P 520827

ON-SITE SEWAGE DISPOSAL SYSTEM HOWARD COUNTY HEALTH DEPARTMENT BUREAU OF ENVIRONMENTAL HEALTH

SUBDIVISION: Waterman Estates LOT NUMBER: 22

ADDRESS: 12451 Petrillo Drive PROPERTY OWNER: Douglas Homes, Inc.

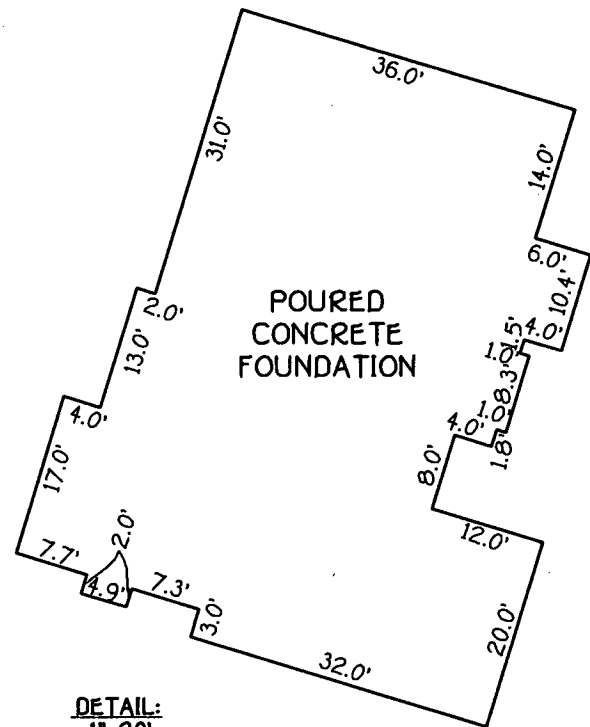
PRE-CONSTRUCTION 9/1/04 Tank set. No plumbing installed. Put the

distribution box at the top of the septic easement and run

INSTALLATION 2-75' to 80' trenches away from the house. (BB)

9/2/04 Septic easement full of intermittent veins of quartzite

and deep sandy clay loam. Hatfields hit 2 veins of quartzite

while digging trenches. One was shallow and they dug through

it. The other vein was deeper and they didn't dig through

it completely. Don't know how long trenches will last before

failure - installed in clay loam and sandy clay loam. I had

Hatfields dig a hole in the septic area and they hit a vein of

quartzite at 7' at that spot. Perc. test notes don't appear to match

soil in septic easement. Future repairs should be done somewhere

away from the septic easement if possible. (BB)

**HOUSE LOCATION
DRAWING**

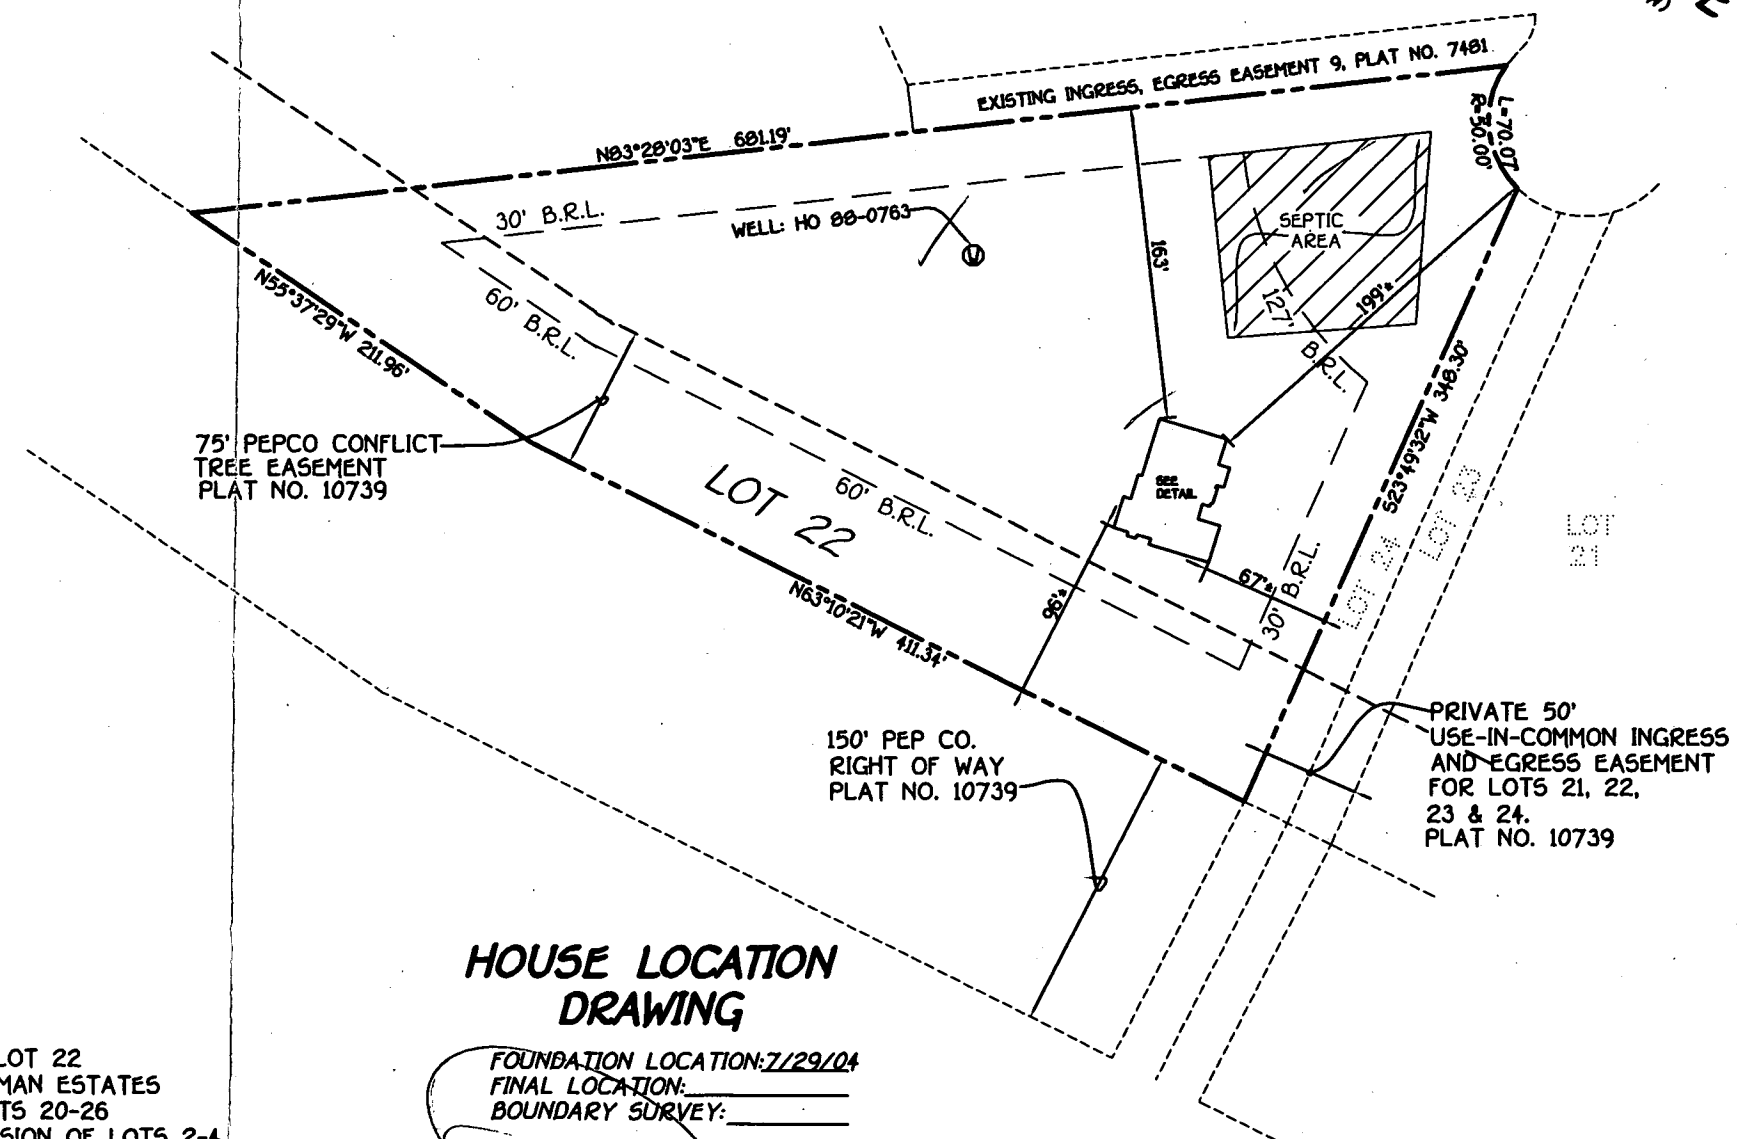
*8/12/04
Wall check of
House
Moved
3'20"
2'20"
further from
well & SDA
OK*
